# Work Order ID 113966

Item Name: Crosstube Turning Detail

| <b>Description:</b> Crosstube Assembly (205/212/412 High Fwd) |  | <b>Part Number:</b> | D212-664-141 |

| DRAWING NO.<br>D212-664-141 | TITLE<br>XTUBE ASSY (205/212/412 HI FWD) | REV. D | DART AEROSPACE LTD<br>ENGINEERING ORDER |               | D.E.O. NO.<br>D212-664-141-D-1 | SHEET NO.<br>SHEET 1 OF 2 | SCALE<br>NTS |

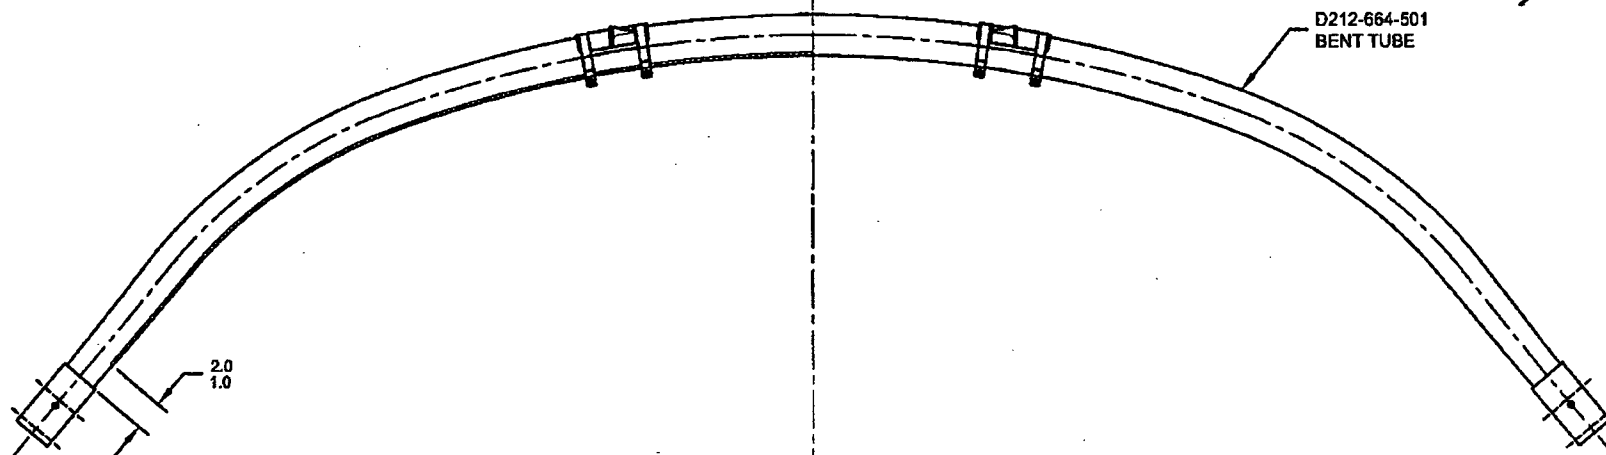
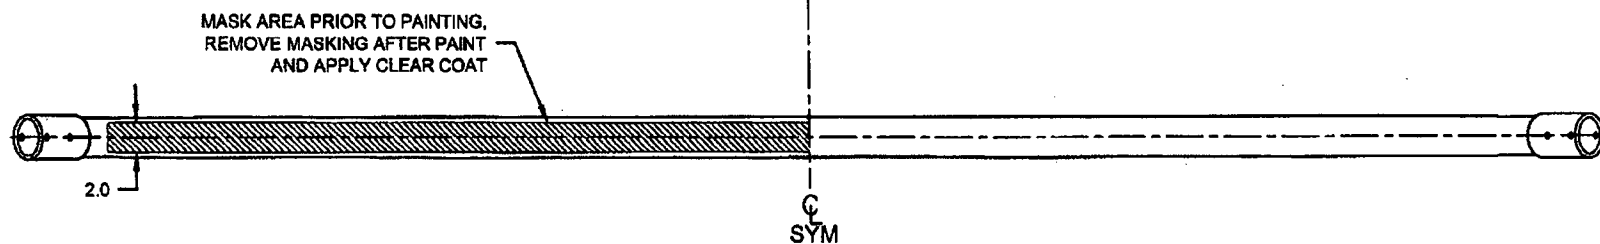
ADD AN INSPECTION WINDOW TO UNDERSIDE OF CROSSTUBE.

NOTES 2 OF SHEET 1 IS AMENDED AS FOLLOWS:

- 2) FINISH: CHEMICAL CONVERSION COAT PER DART QSI 005 4.1  
PRIME INSIDE AND OUTSIDE PER DART QSI 005 4.2  
MASK UNDERSIDE OF CROSSTUBE AS SHOWN (HATCHED AREA) AND  
PAINT OUTSIDE PER DART QSI 005 4.2  
REMOVE MASKING AND APPLY CLEAR COAT
